Access Compliance Report Public Rights-of-Way (RR Crossings)

Intersection ID: 10035790	Main Street: REMOUNT_RD	Location: N/A
ADA ID: 4968DD1CAD6F	Overall Compliance: No	Severity Score: 0.0
Codes/Mitigation Info/Possible Solution		Field Measurements/Component Compliance

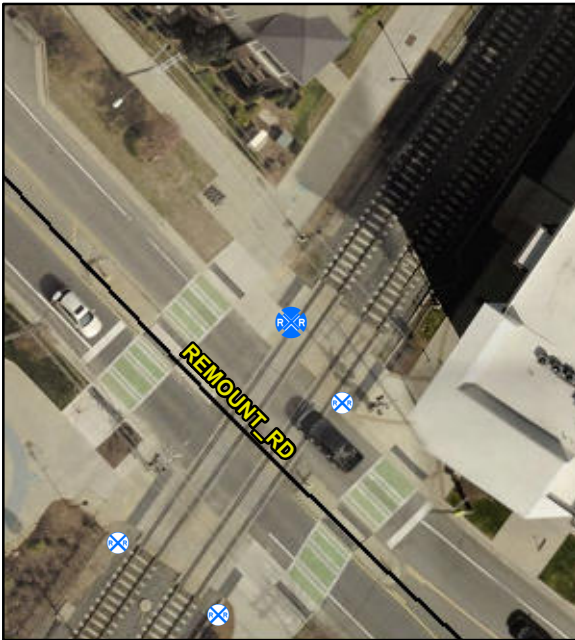
Compliance	Description	Data
Yes	DWS Provided?	Yes
Yes	DWS Contrast?	Yes
Yes	DWS Width (in)	Yes
Yes	DWS Length (in)	36.0
No	DWS Offset (in)	38.0
No	Pedestrian Gate?	No
N/A	DWS Outside Gate?	N/A
N/A	Rail Type?	LightRail
No	Flangeway Gap (in)	3.0
Yes	Sidewalk Width (in)	58.0

Remove & Replace Detectable Warning System. Provide Pedestrian Gate. Remove & Replace Walking Surface Adjacent to Rail.
